APPLICATION NO.	FILING DATE	FIRST NAMED INVENTOR	ATTORNEY DOCKET NO.	CONFIRMATION NO.
10/023,932	12/21/2001	Makoto Terui	I272. C0498	7763

Office Action Summary	Application No.	Applicant(s)
	10/023,932	TERUI, MAKOTO
Examiner	Art Unit	
Leonard S Liang	2853

DETAILED ACTION

FIG. 1

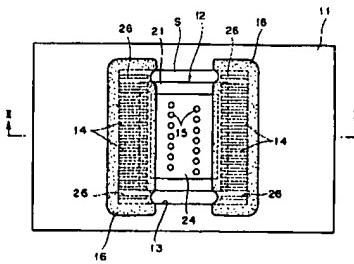
- {claim 1} A tape provided with a base (figure 1-2, reference 21); a base having electrothermal transducers formed therein, the electrothermal transducers being adapted to heat a liquid used for printing and introduced through a liquid introduction passage and to eject the liquid through an ejection port forming

surface (figure 2, reference 20; column 7, lines 56-67); a tape member arranged at a periphery of an accommodating portion where the base is accommodated, and having connecting portions electrically connected to the electrothermal transducers in the base (figure 1-2; reference 14; column 6, lines 31-51); wherein the tape member includes reinforcement portions having a larger rigidity than that of the connecting portions and connected at one end to electrode portions on the base (figure 1, reference 16; abstract; column 2, lines 46-49; column 6, lines 31-51)

- {claim 2} the reinforcement portions are arranged to face corners of the base (figure 1, reference 16)
- {claim 9} a conductive layer having connecting portions joined to the tape member, the connecting portions being connected to electrode portions on the base, the electrode portions being electrically connected to the electrothermal transducers (figure 1, reference 14; column 6, lines 31-51); a body having a liquid supply portion for introducing the liquid to the base (figure 2, reference 19); wherein the connecting portions include branch portions branched at one end and electrically connected to the electrode portions on the base and reinforcement portions having a larger rigidity than that of the branch portions and connected at

- {claim 10} the reinforcement portions of the connecting portions are arranged to face corners of the base (figure 1, reference 16)
- {claim 18} the branch portions and the reinforcement portions of the connecting portions are arranged in a direction perpendicular to the direction of array of ejection ports in the ejection port forming surface (figure 1)
- {claim 19} the liquid is an ink (column 1, lines 17-39)
